Wollongong Local Planning Panel Assessment Report | 13 March 2019

WLPP No.	Item No. 3
DA No.	DA-2018/1531
Proposal	Residential - demolition of existing structures, remediation works, tree removals and Subdivision boundary adjustment, construction of a dual occupancy on each new lot and subsequent Torrens title two (2) lots Subdivision of each dual occupancy
Property	178-180 Lawrence Hargrave Drive, THIRROUL Lot 2 DP 329046 and Lot A DP 392508
Applicant	Develop My Land
Responsible Team	Development Assessment and Certification – City Wide Planning Team (JS)

ASSESSMENT REPORT AND RECOMMENDATION

Drawing Name: LANDSCAPE PLAN	Job No. DML 17/010	Dwg.No. L-01
FOR: ILLAWARRA PROPERTY HOLDINGS PTY LTD	Scale 1:250 (A3)	Date 17.10.18
		Rev. B

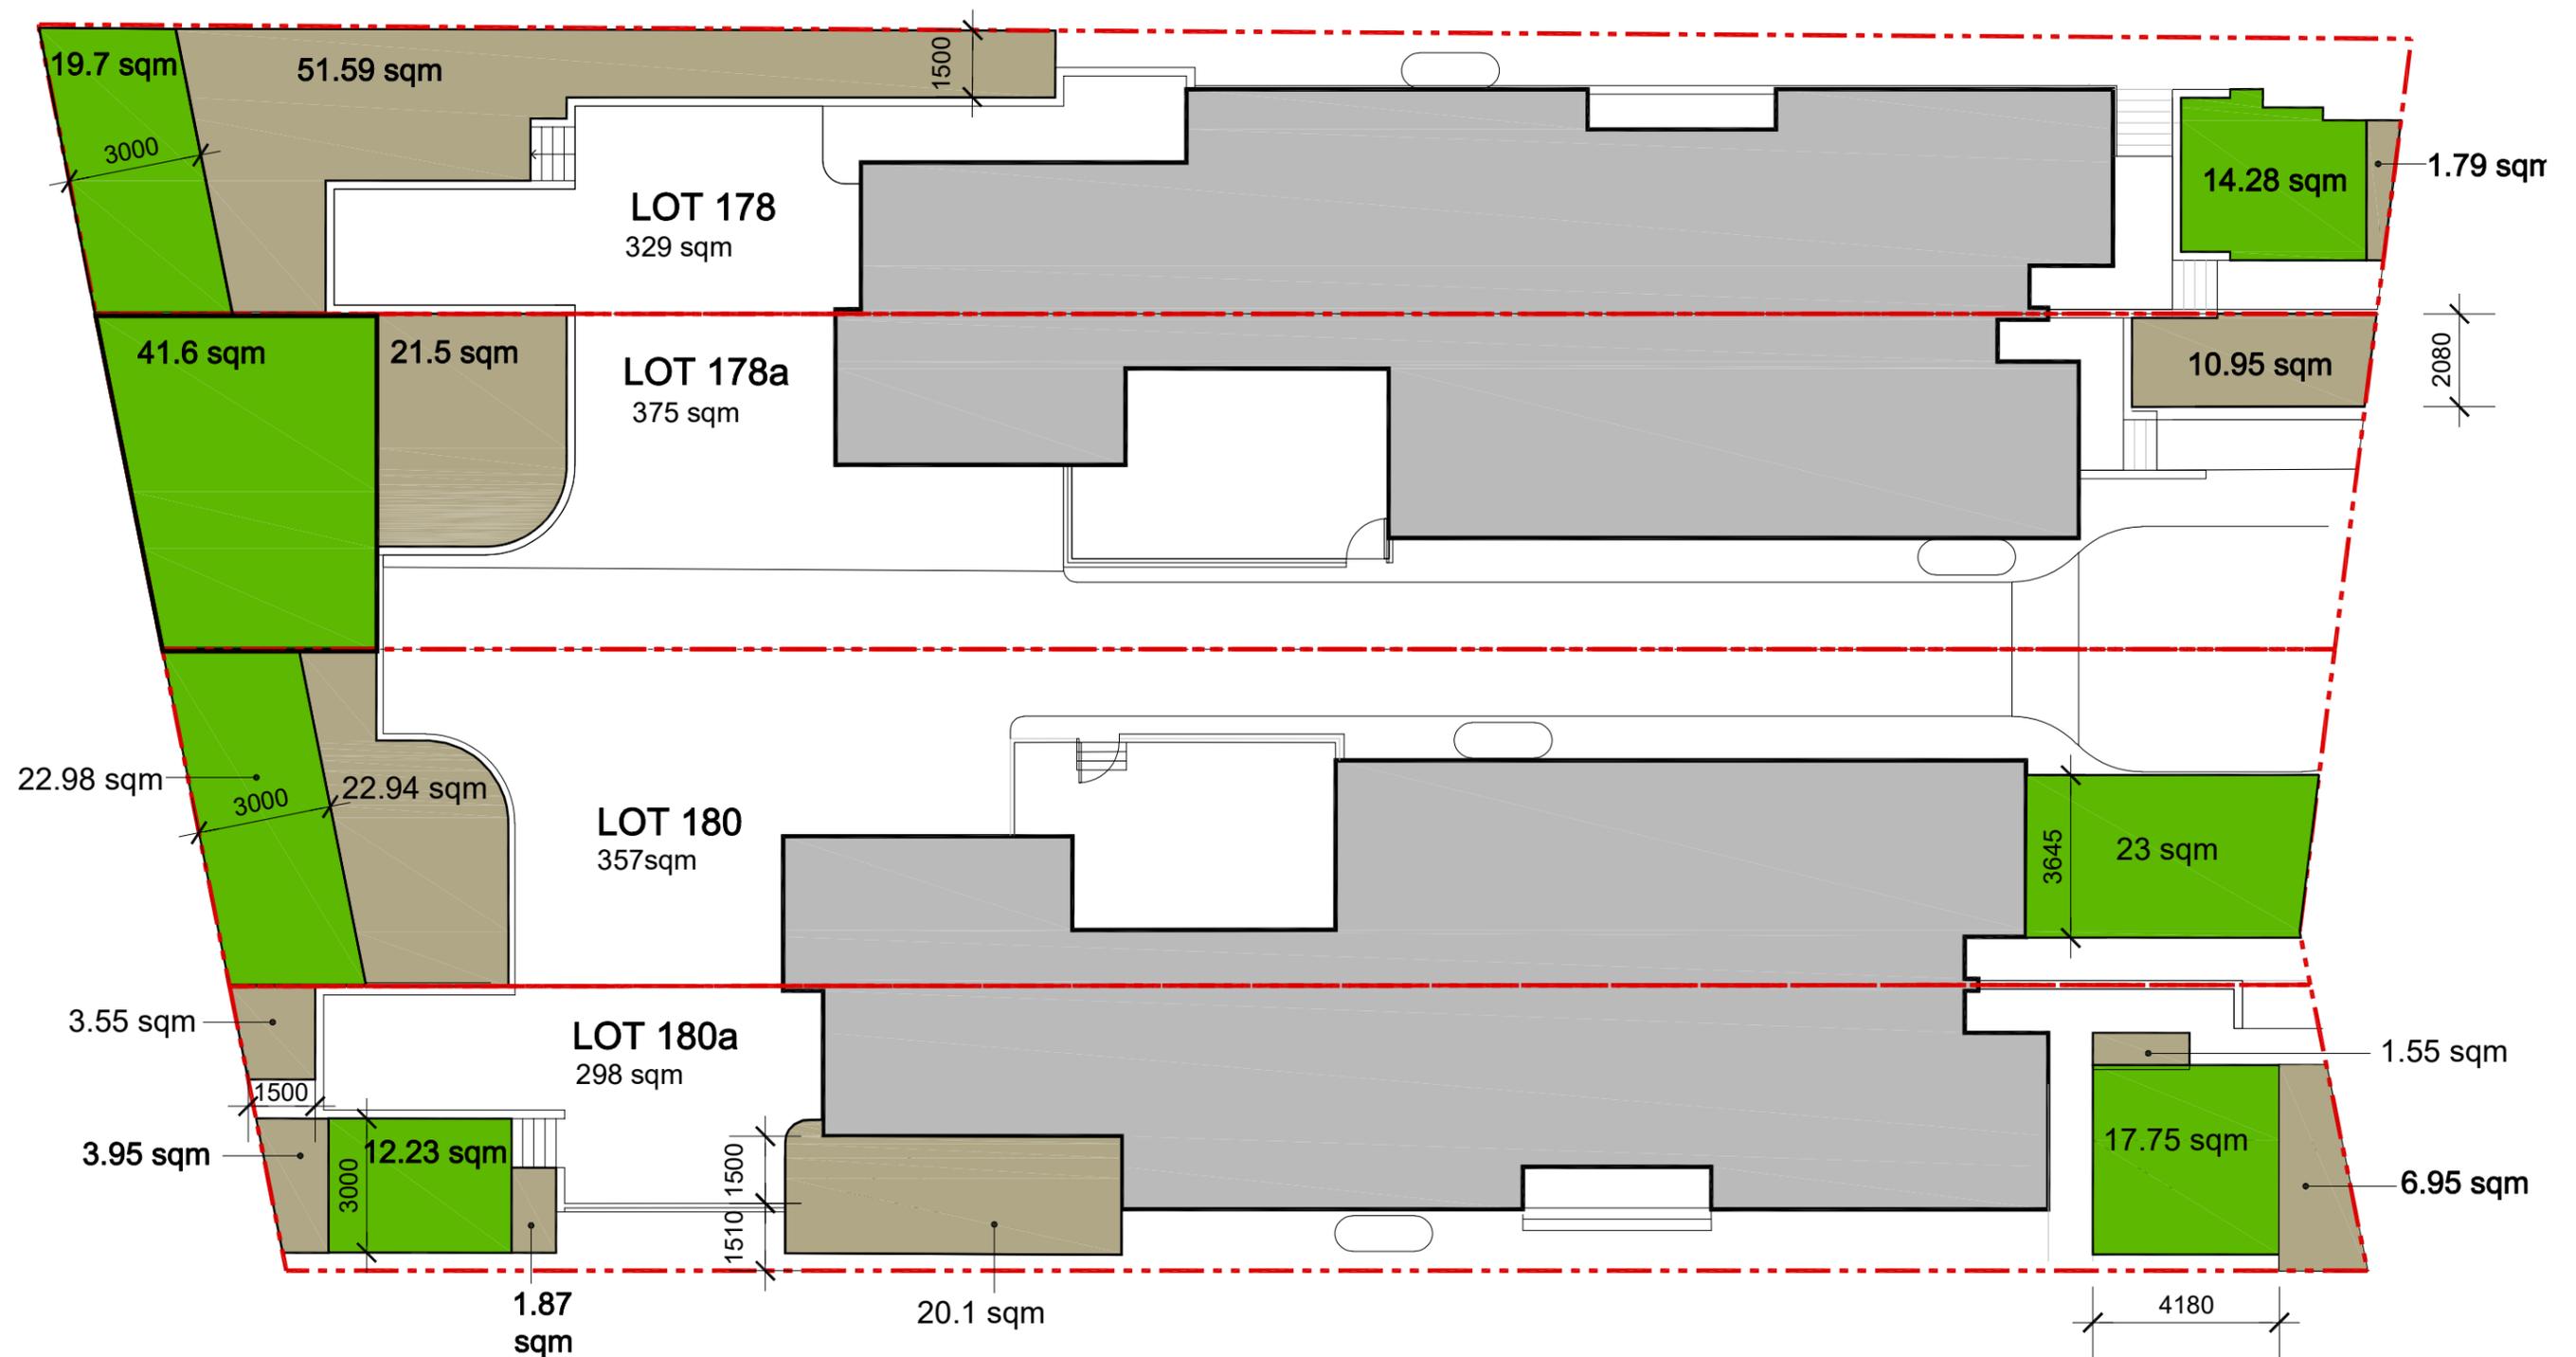
<p>9. Waste Storage</p> <p>The bins will likely be stored on the driveway area and impact on manovering and passing on the already narrow driveway.</p>	<p>Bin storage locations are shown on the landscape plan and are considered satisfactory. The driveway width, excluding the bin storage areas exceeds the minimum width requirements.</p>
<p>10. Retaining wall</p> <p>Concerns are raised with regard to the stability of the existing retaining wall located on the boundary of 180 and 182 Lawrence Hargrave Drive and the additional pressure that would result from the proposed development, and changes to the pressures on the wall resulting from the proposed remediation works.</p>	<p>Structural certification for the existing wall has been provided which requires the piercing of the development to levels below the zone of influence of the existing wall. The final Occupation Certificate for the wall has also been provided to Council. Conditions are recommended in this regard, as provided at Attachment 4, including the requirement for the submission of a dilapidation report considering adjoining properties to the PCA prior to works commencing.</p>

<p><u>4.17. Retaining walls</u></p>	<p>A series of retaining walls are proposed throughout the site and details have been provided on the submitted landscape plan. Conditions will be recommended with regard to engineering design for those walls and certification.</p>	<p>Yes</p>
<p><u>4.18 Swimming Pools and Spas</u></p>	<p>No swimming pools or spas are proposed as part of the subject application.</p>	<p>N/A</p>
<p><u>4.19 Development near railway corridors and major roads</u></p>	<p>The site has frontage to Lawrence Hargrave Drive. See discussion at SEPP (Infrastructure) 2007 at section 2.1.2 of the main report.</p>	<p>See above.</p>
<p><u>4.21 Additional controls for Dual Occupancies minimum site width</u></p>	<p>The proposal seeks consent for a variation to the minimum site width requirements.</p> <p>A variation request statement has been submitted in this regard, and contends that the site is suitable for the development as it is not significantly constrained by hazards, and the development would not adversely impact the amenity of surrounding properties. The variation is considered capable of support in this case.</p>	<p>No - Variation to WDCP 2009 requested and supported</p>

The submission of a final Landscape Plan to the Principal Certifying Authority, prior to the release of the Construction Certificate. The final Landscape Plan shall address the following requirements:

- 33.6 To mitigate impact to adjoining dwelling a continuous hedge is to be established along northeastern and south western boundaries for the length of property boundary. Recommended species: *Callistemon viminalis* 'Slim', *Photinia glabra* *Rubens*, *Viburnum tinus*, *Syzygium australe* *Aussie Southern*, *Syzygium*, 'Resilience', *Viburnum odoratissimum* *Dense Fence* or *Waterhousea floribunda* *Sweeper*. Minimum spacing 1000mm. Minimum pot size 5 lt. A further list of suitable suggested species may be found in Wollongong Development Control Plan 2009 – Chapter E6: Landscaping.

DRAWING: C.01 - CONCEPT DRAINAGE PLAN
DWG. No: OCE12779/C01/DA/E

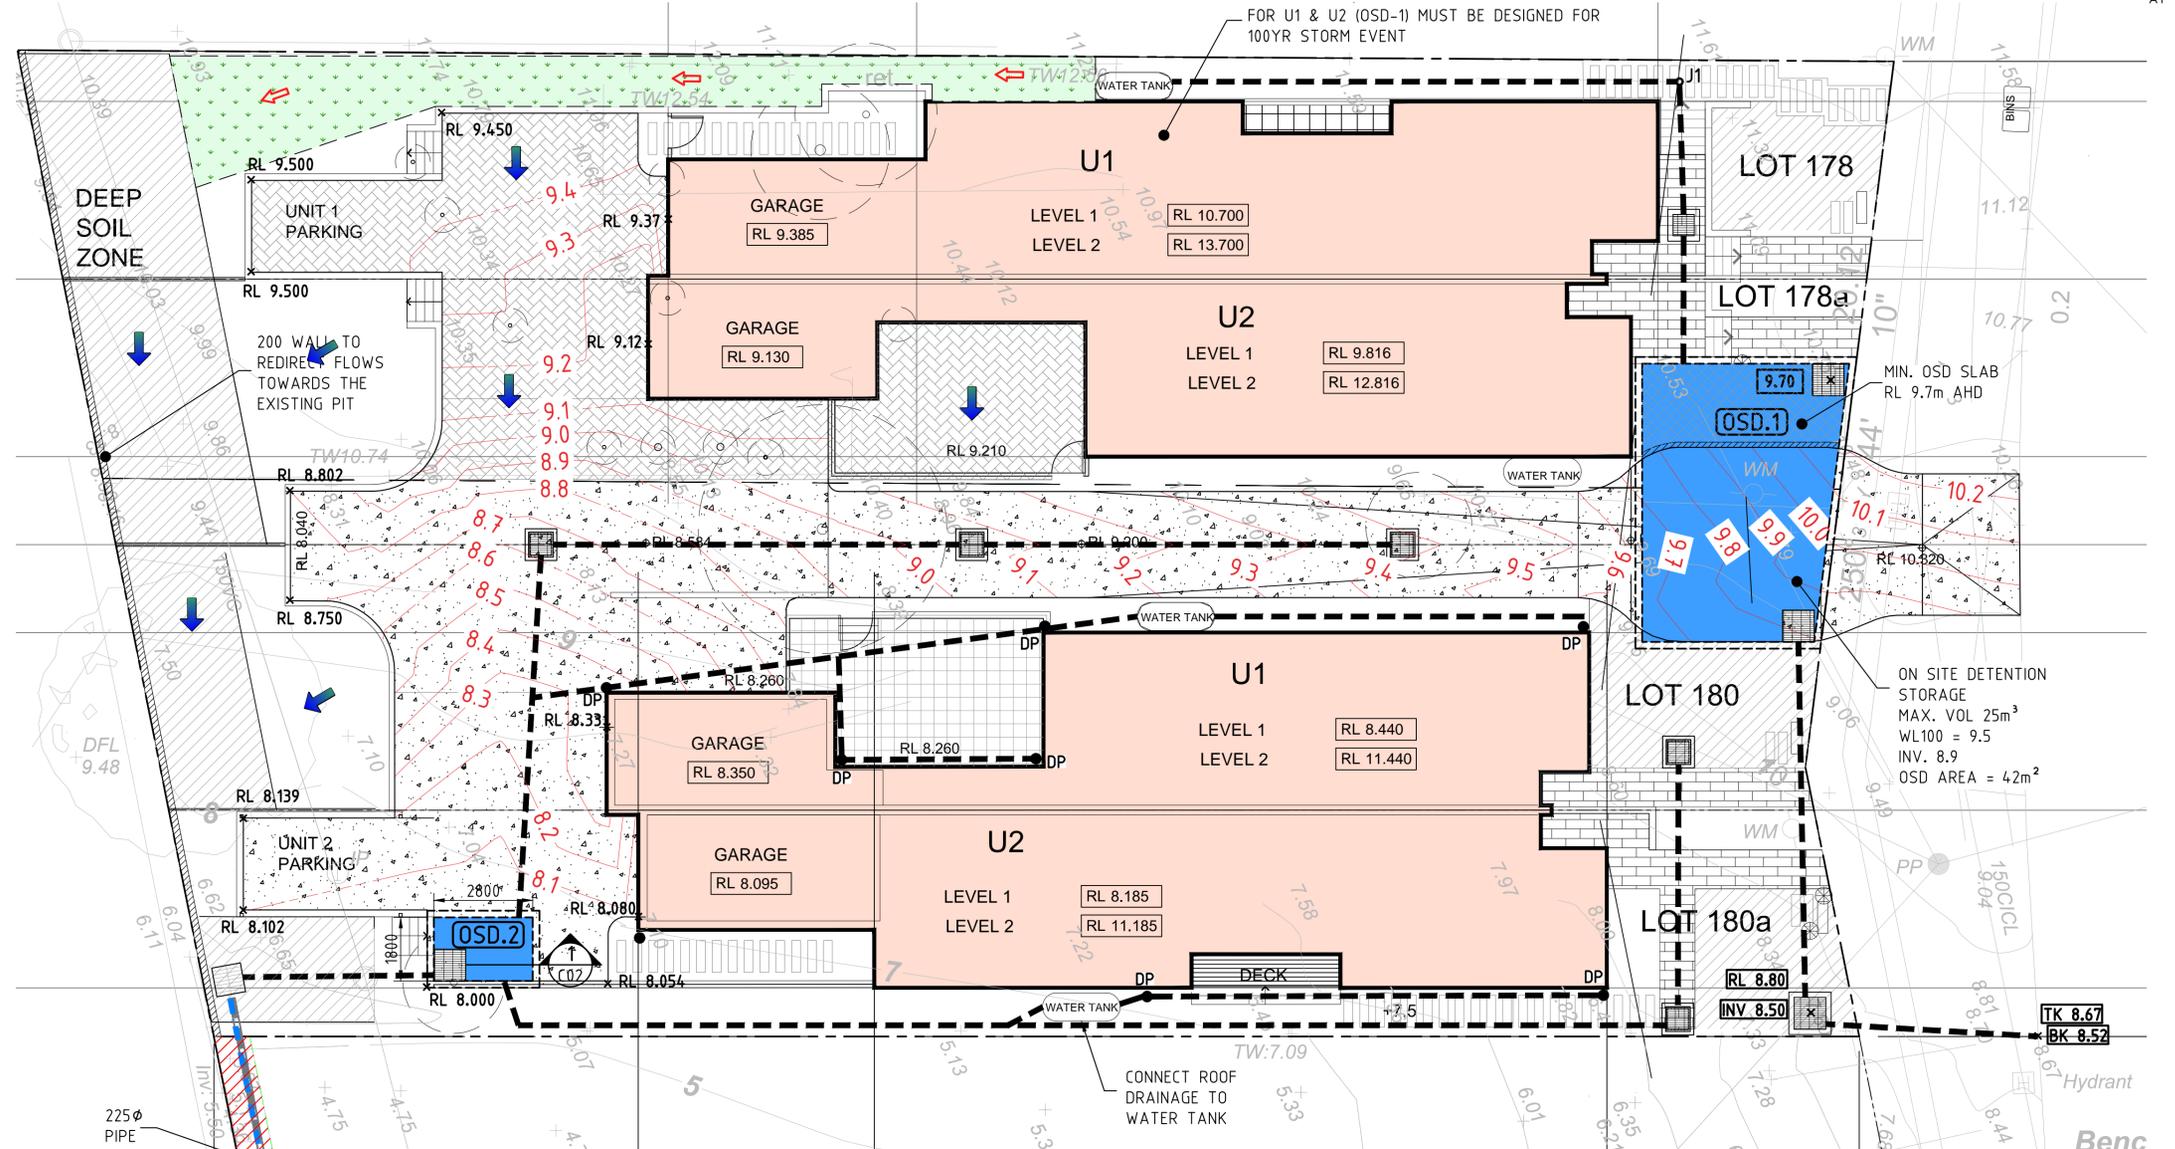
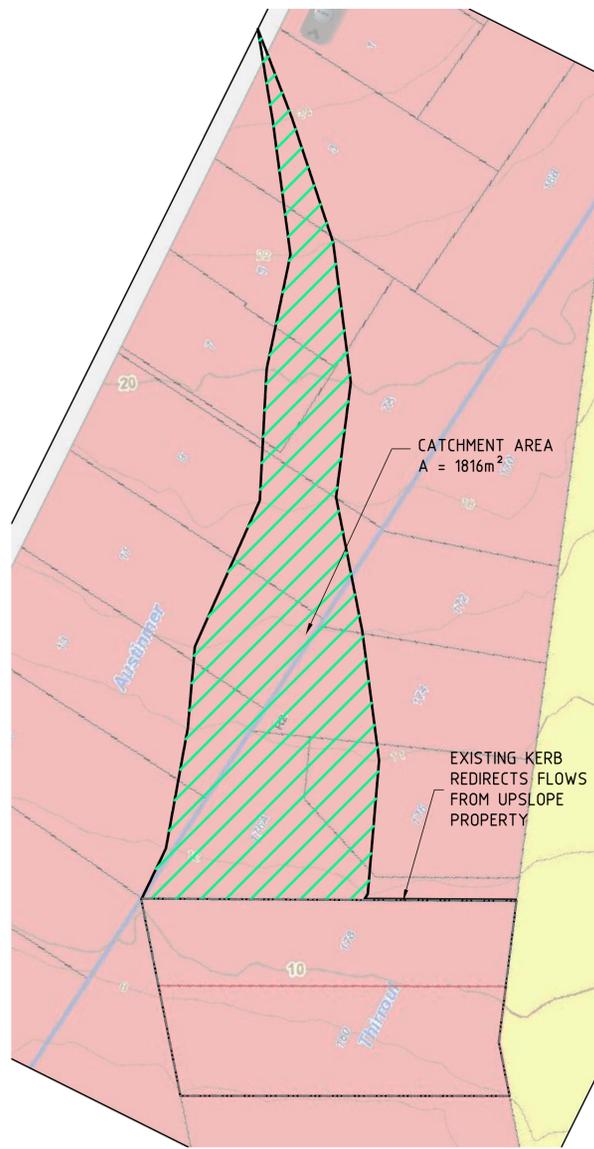
A review of the concept drainage plan reveals that the proposed site is not within the 100 year ARI or Probable Maximum Flood (PMF) extents. The site levels are above the adjacent flood levels and therefore it is unlikely that this site will be flood affected. The proposal has also been designed to not result in any additional flood affectation on properties downstream.

Council's Stormwater Officer, has assessed the proposal against the requirements of this Chapter. A stormwater concept plan and land survey information were submitted with the application and are considered to be satisfactory.
